Students Hostel
at Chepâk

From H. IRWIN, Esq., C.I.E., Consulting Architect to the Government of Madras, to the Chief Engineer, Public Works Department, dated Chepâk, 18th August 1894, No. 1403.

NOTE BY TECHNICAL SECTION.

Name of work. Constructing Port officers office & godowns & Dy. Telegraph Masters Quarters at Pamban in the Madura District.

CHEPAUK COMPOUND IN 1893

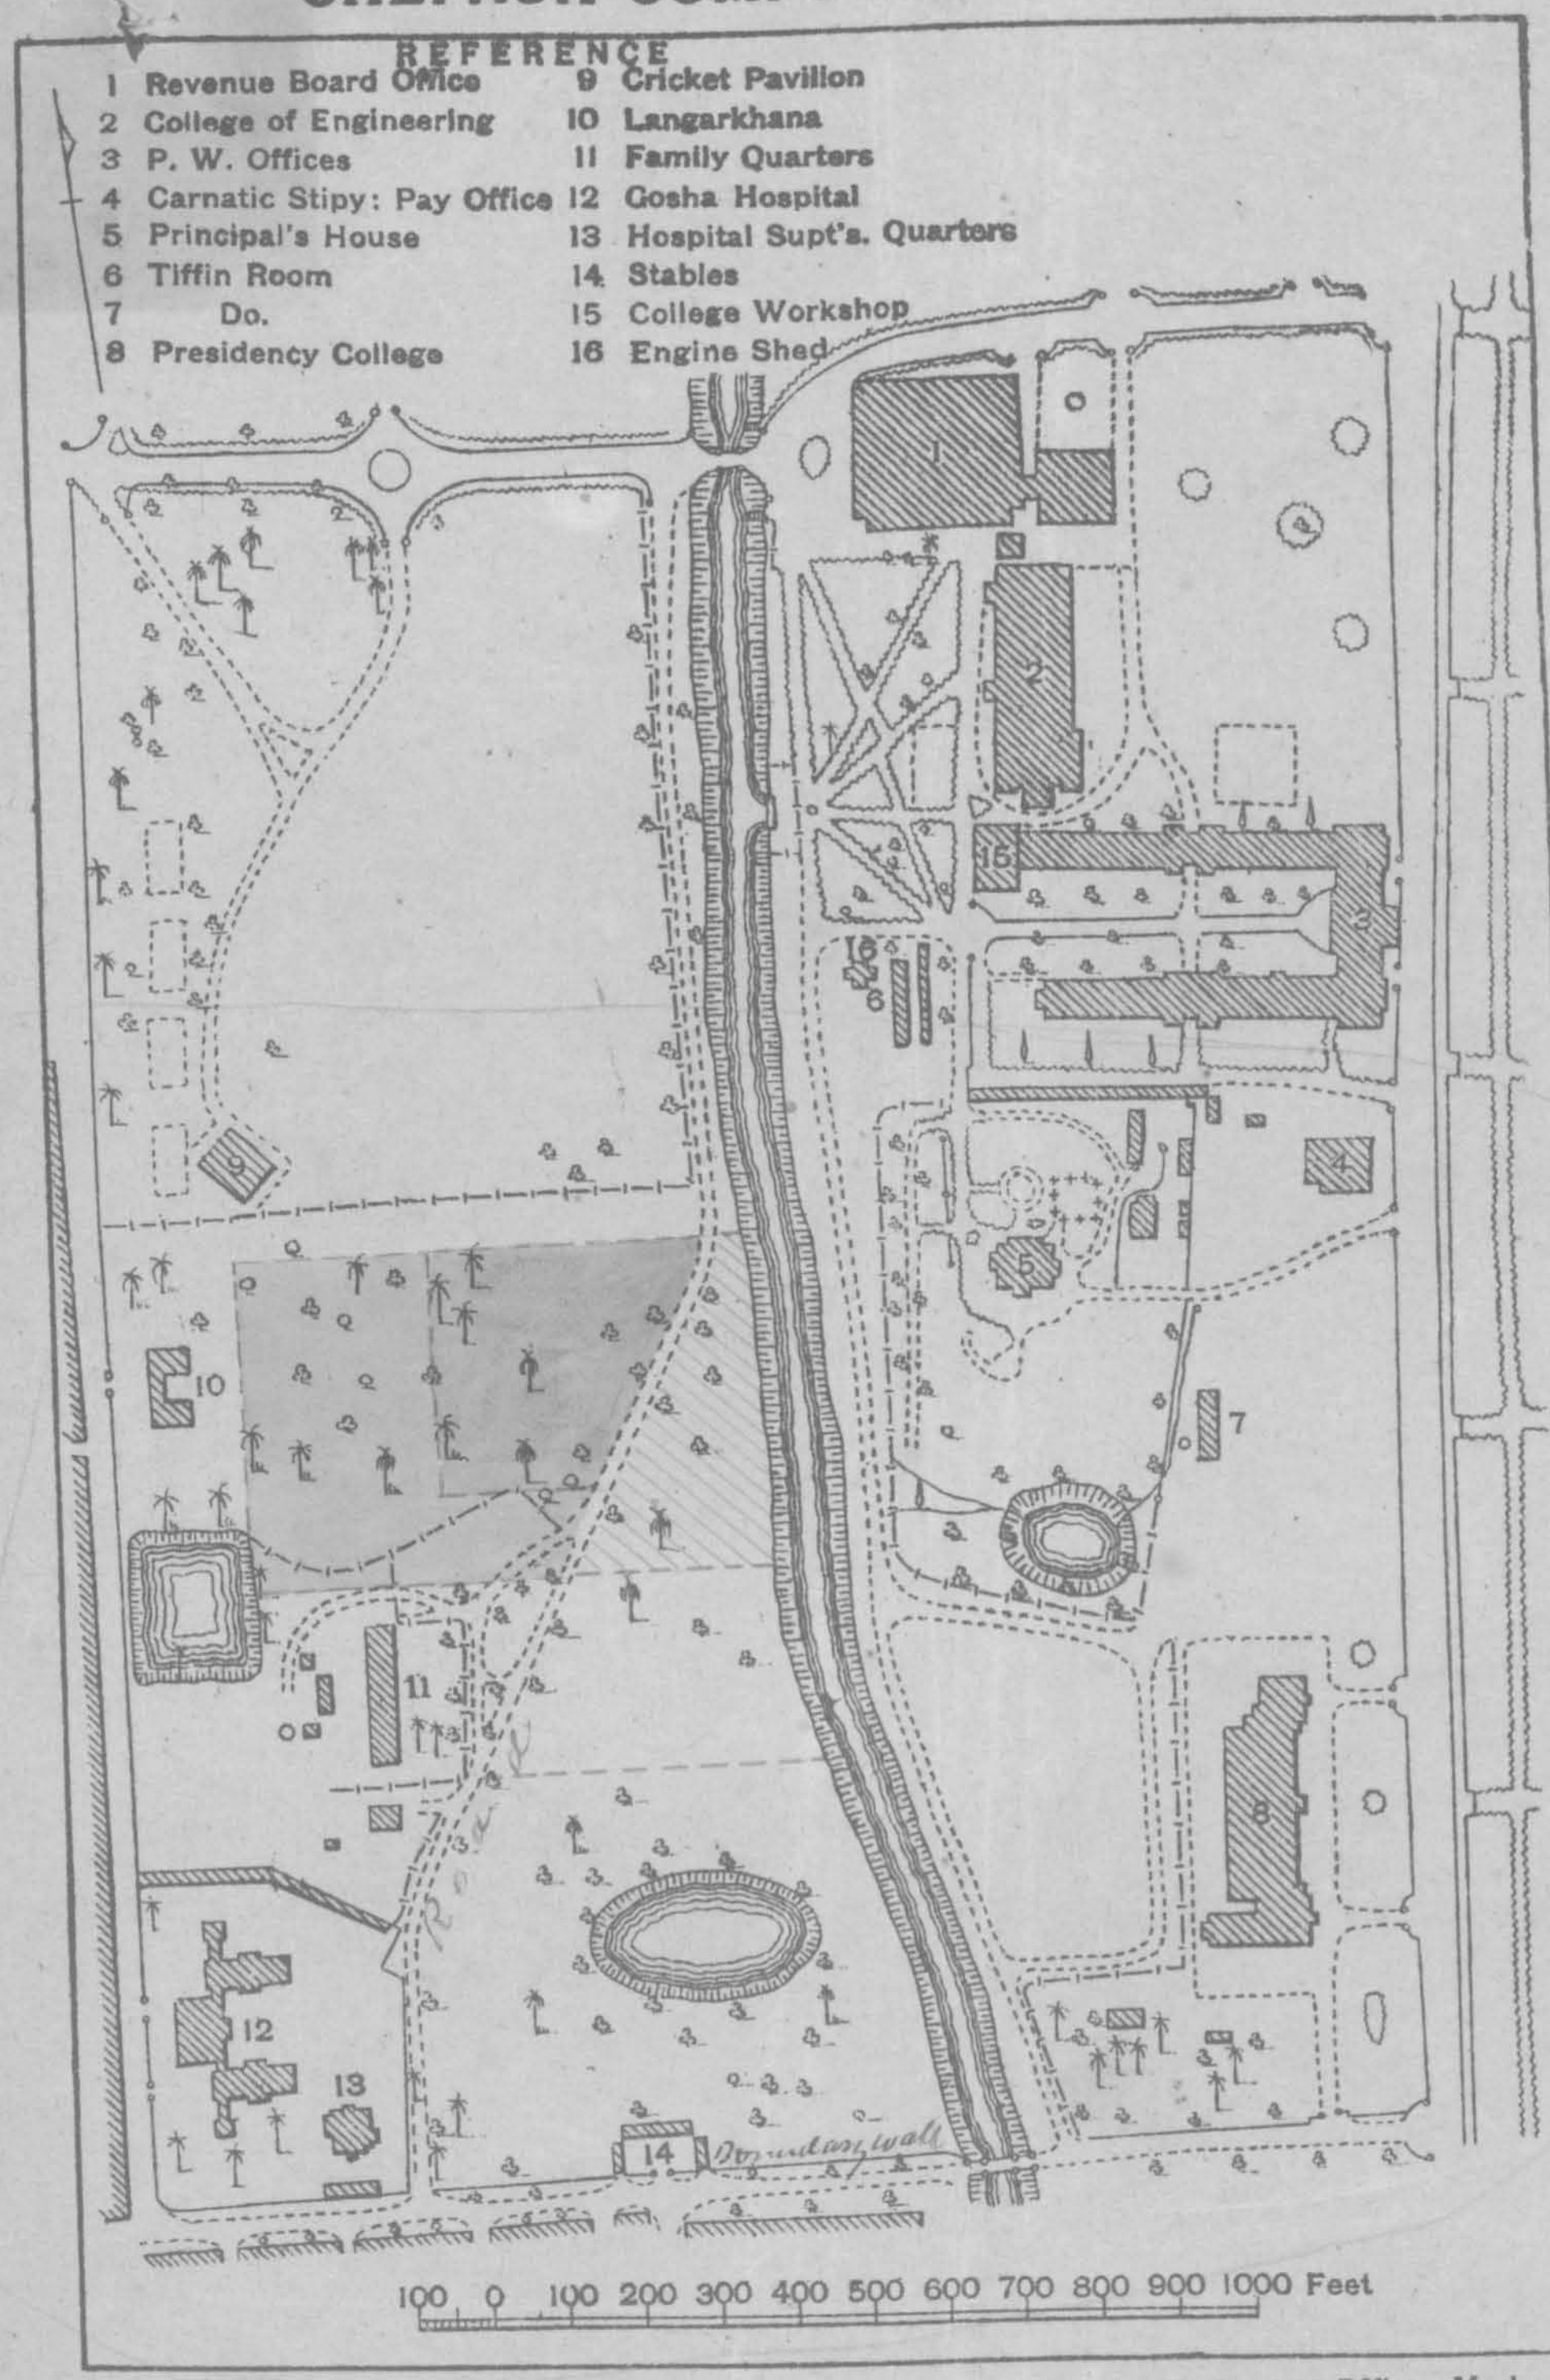
I always understood that the portion of ground to be given for the Students' Hostel at Chepak was as described in Mr. Irwin's letter of Aug. 18. 1894 No. 1403 - and certainly not only the miserable little corner cross hatched red. The Con. Architect I think should be instructed to make designs for the Hostel on the whole of the ground he alludes to - wherever it appears to him to come in best, taking care to leave plenty of space in his plans for future extensions. What is not built on shd. be made into a garden, and there wd. be no objection to filling in the tank - Tennis courts too might be shown.

The tank could be turned into an A1 swimming bath, I should say. ~~But that may be left to the management of the Hostel~~

Present ground coloured .... blue.
Additional ground proposed by Consulting Architect -- red.
Further portion asked for by Principal, cross hatched red.

The area intended to be made over for the Students' Hostel is the whole of the space between the boundary wall, the canal and the road, and not merely the small triangle at the northern end of this space.

2. Plans should be prepared on this ground, care being taken to allow plenty of space for future extensions, what is not built over being used as a garden or for tennis courts, and the tank near the southern boundary being filled up if necessary.

CHEPAUK COMPOUND IN 1893

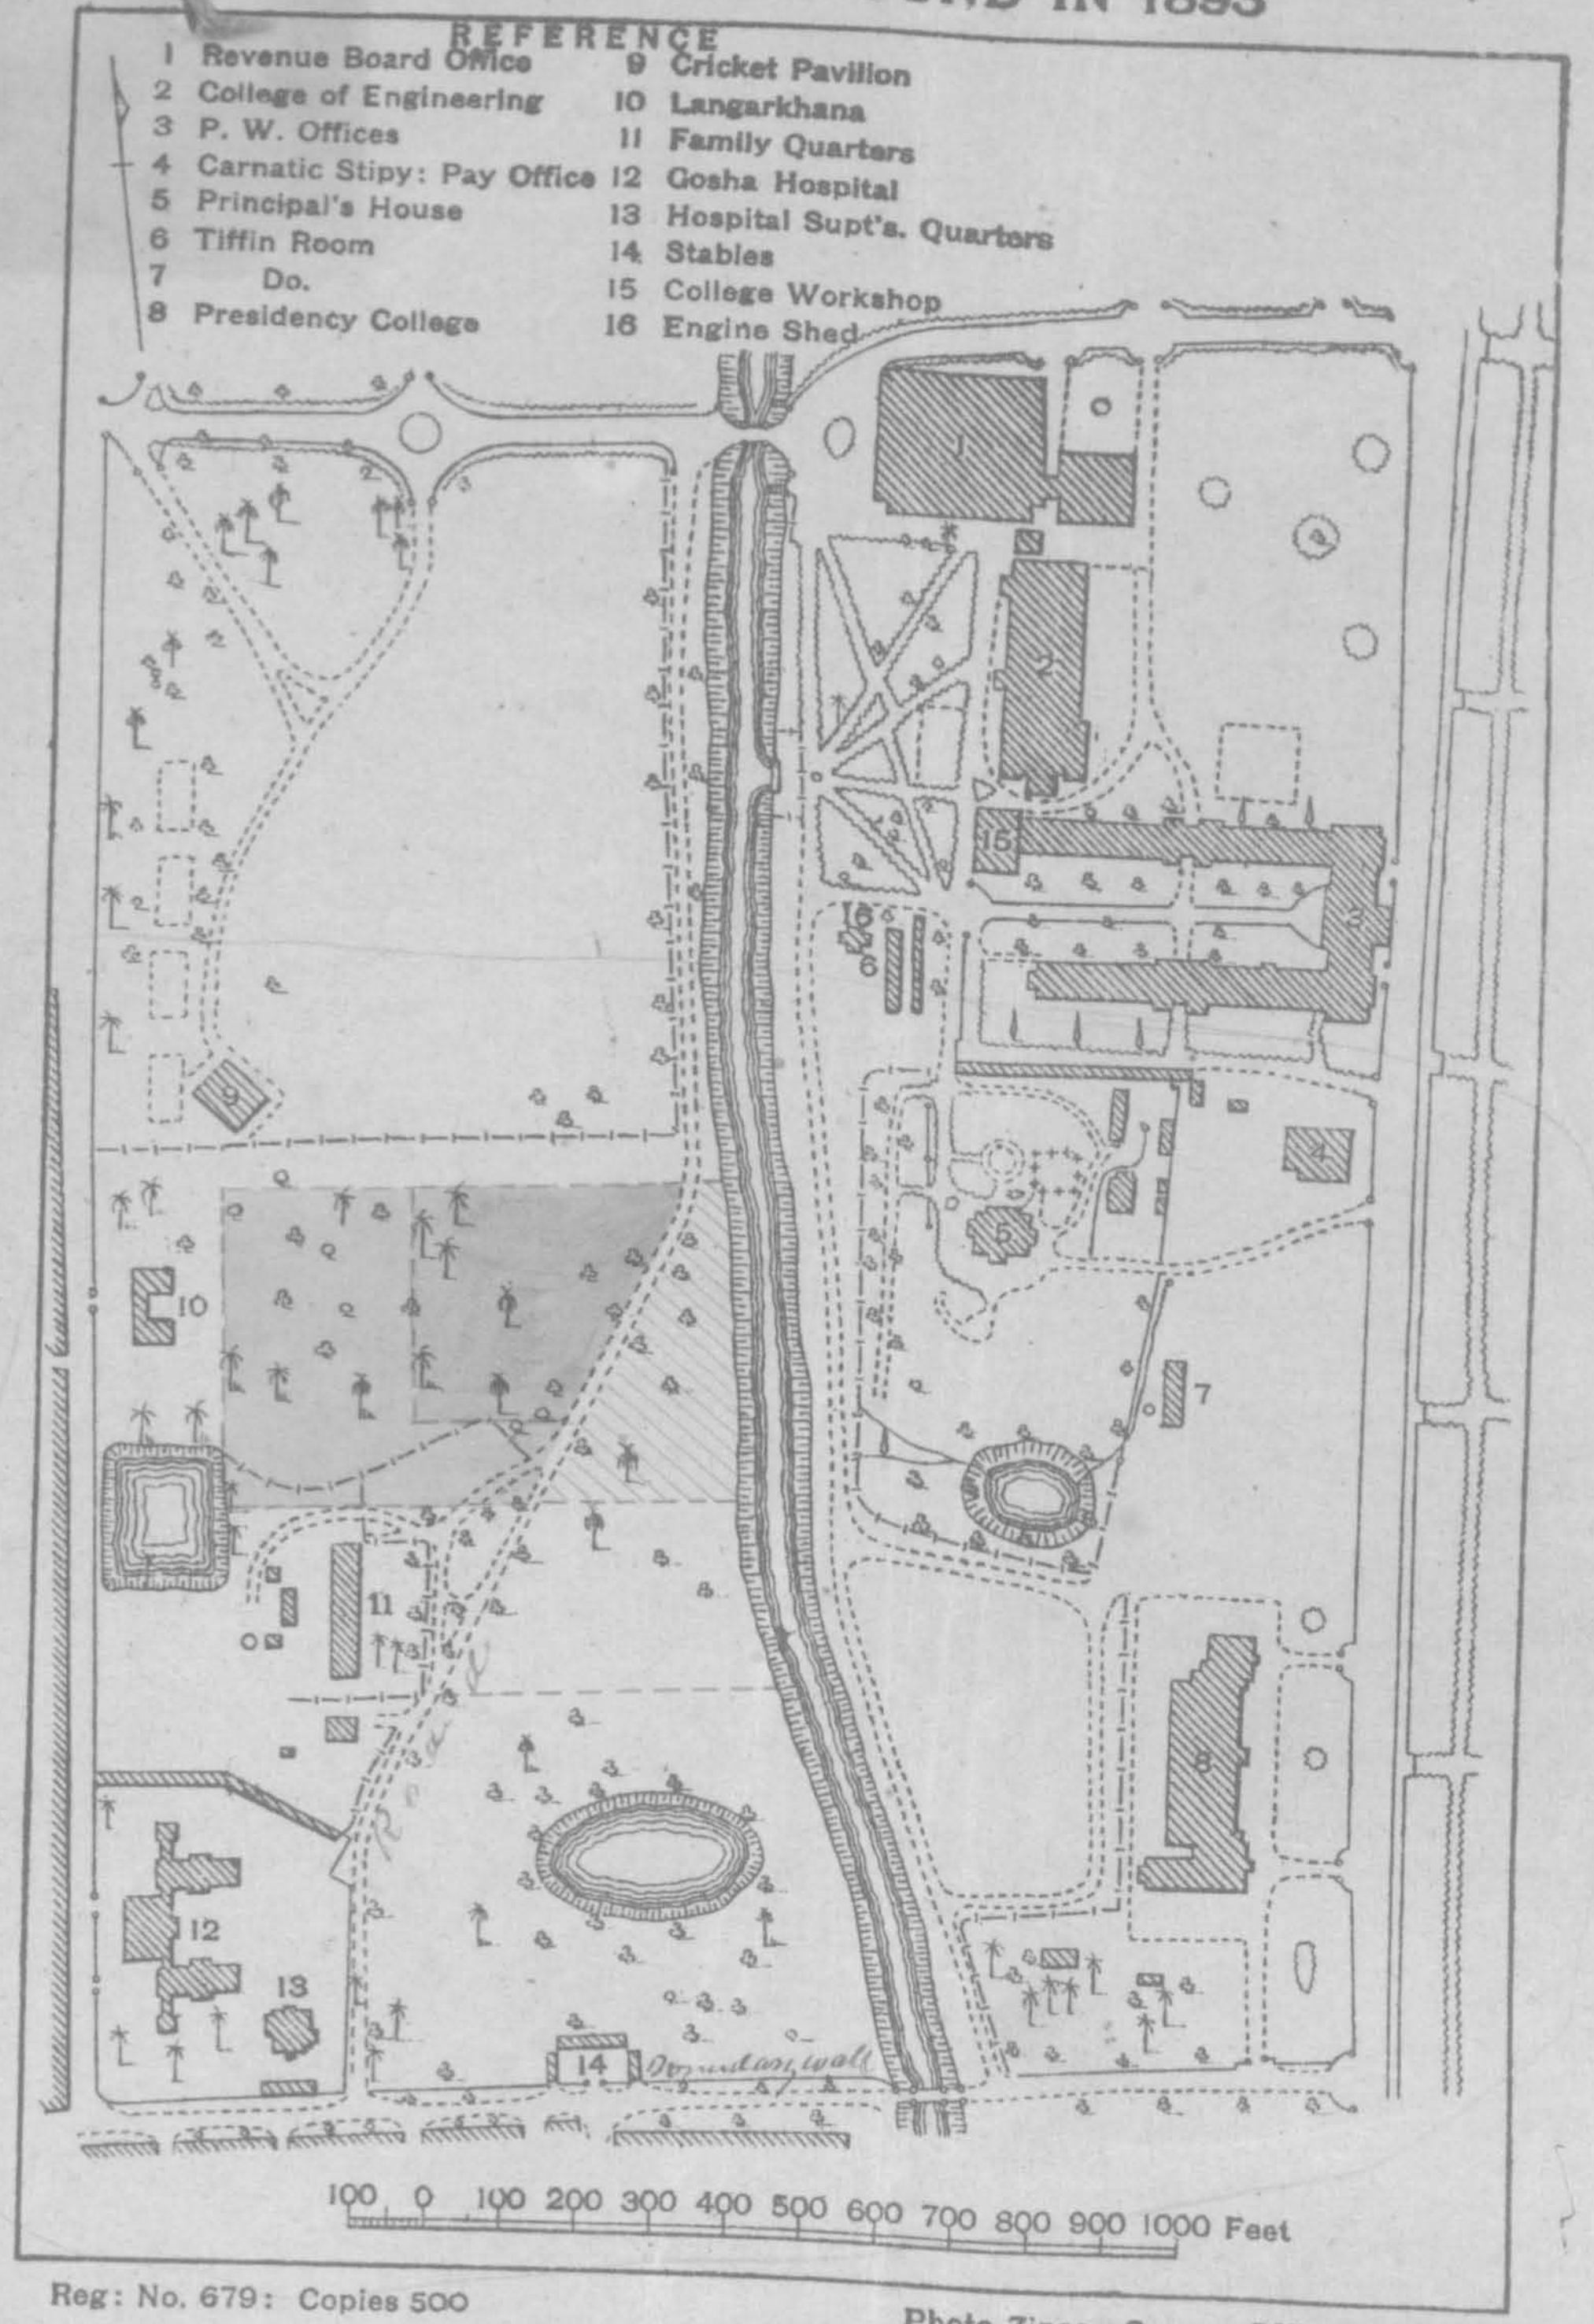
I always understood that the portion of ground to be given for the Students' Hostel at Chepak was as described in Mr. Irwin's letter of Aug. 18. 1894 No. 1403 - and certainly not only the miserable little corner cross hatched red. The Consg. Architect I think should be instructed to make designs for the Hostel on the whole of the ground he alludes to - wherever it appears to him to come in best, taking care to leave plenty of space in his plans for future extensions. What is not built on shd. be made into a garden, and there wd. be no objection to filling in the tank - tennis courts too might be shown.

The tank could be turned into an A1 swimming bath, I should say. But that may be left to the management of the Hostel

Present ground coloured - - - - - - - - - - - - - - blue.
Additional ground proposed by Consulting Architect - - red.
Further portion asked for by Principal, cross hatched red.

The area intended to be made over for the Students' Hostel is the whole of the space between the boundary wall, the canal and the road, and not merely the small triangle at the northern end of this space.

2. Plans should be prepared on this ground, care being taken to allow plenty of space for future extensions, what is not built over being used as a garden or for tennis courts, and the tank near the southern boundary being filled up if necessary.
